Access Compliance Report

Public Rights-of-Way

| Intersection ID: 29425 | Main Street: BRADSTREET_COMMONS_WY | Cross Street: NOVELLA_DR | Location: W |
| ADA ID: D11B887DF384 | Ramp Type: Perp | Initial Pass/Fail: Fail | Overall Compliance: No |

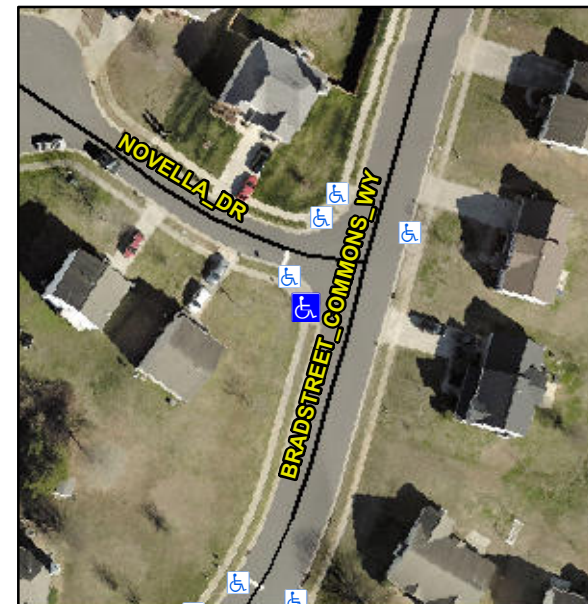
Remove & Replace Entire Ramp.

Not Found, R304.5.1, R304.2.2

| Compliance | Description | Data | Compliance | Description | Data |
|------------|-----------------------|-------|------------|-----------------------------|------|
| N/A | Ramp Length (in) | 48.0 | No | Ramp Slope (%) | 9.5 |
| No | Ramp Width (in) | 47.0 | Yes | Ramp XSlope (%) | 1.6 |
